AT&T–Huntsville C.O

Replacement of the existing AHU-1 Phase-2

## **ADDENDUM #1 (01/17/2019)**

SHEET TITLE  
BSMT FLR MECHANICAL ROOM-ELECTRICAL  
WL8412

**PARTIAL BSMT FLR-MECH ROOM**  
**ELECTRICAL RENOVATION PLAN**  
SCALE: 1/2" = 1'-0"

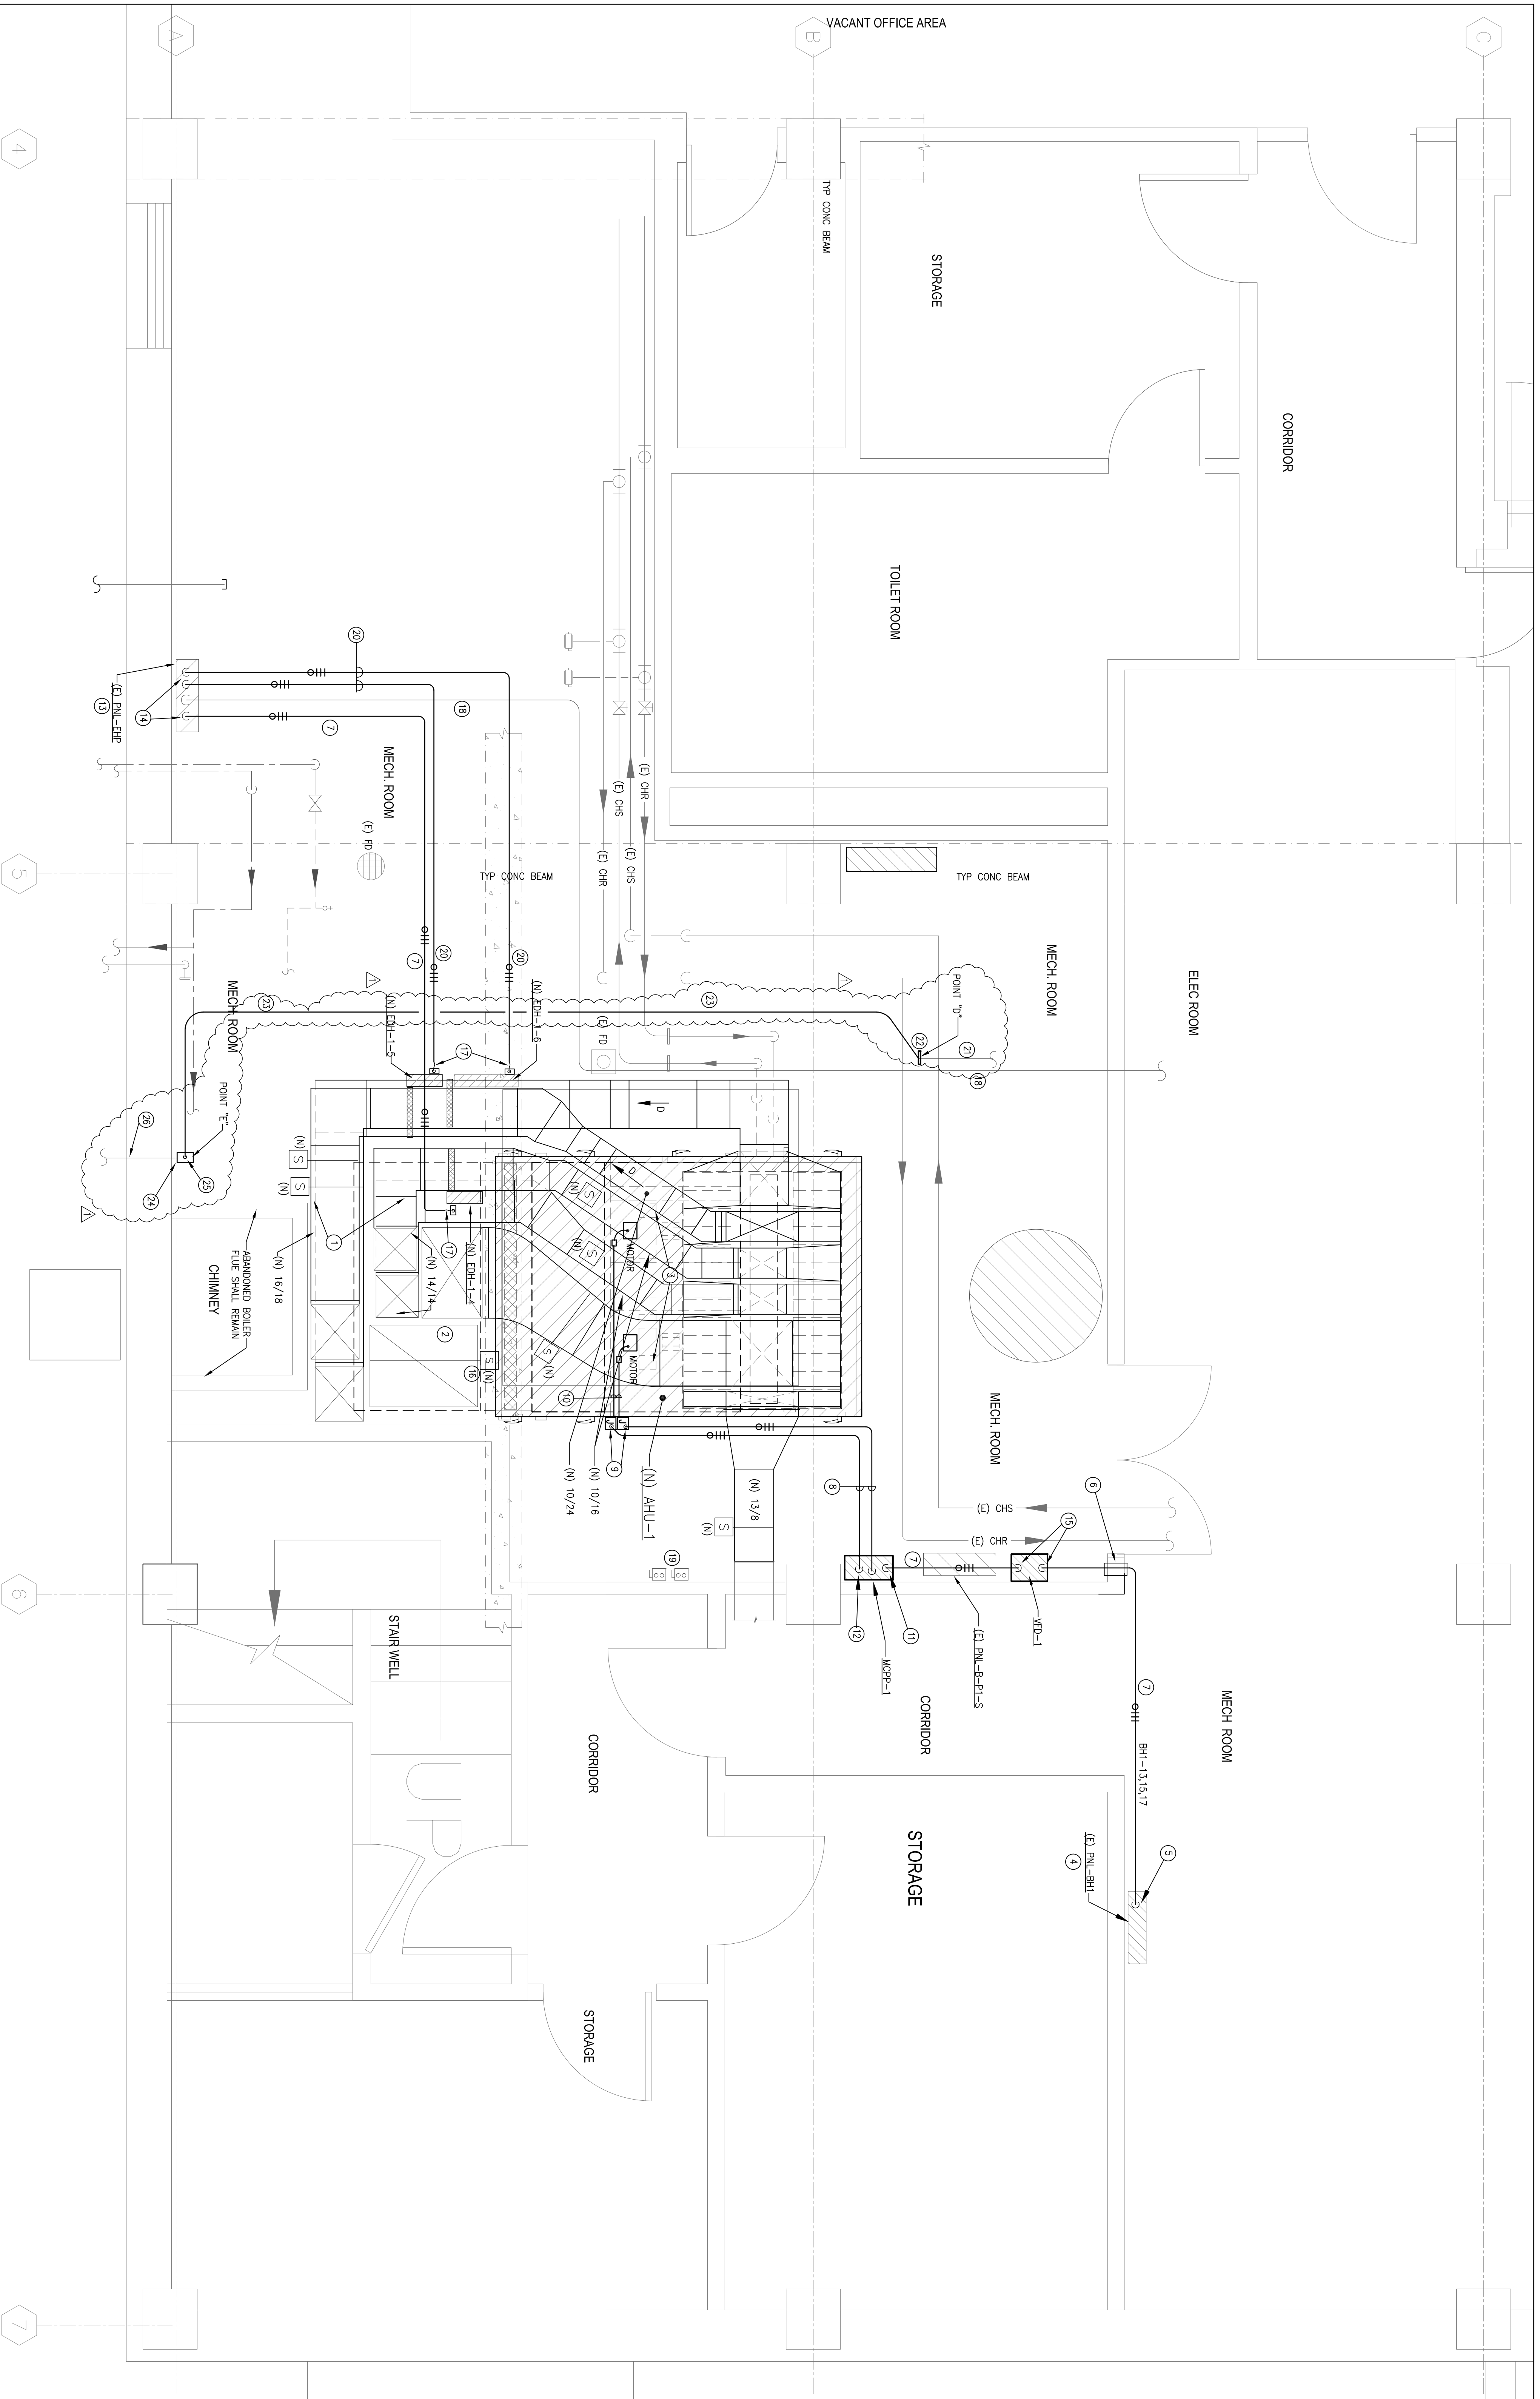
1. Find the attached revised electrical DWG. E1.01 and E1.03.
2. Fire Alarm system shall be furnished, installed, programmed, tested, and placed in normal working conditions as per requirements of bid DWG. E1.01. New VFD shall be programmed for AHU shut down by VFD mfr. All commissioning shall be witnessed by AT&T's bldg. manager and BECK.
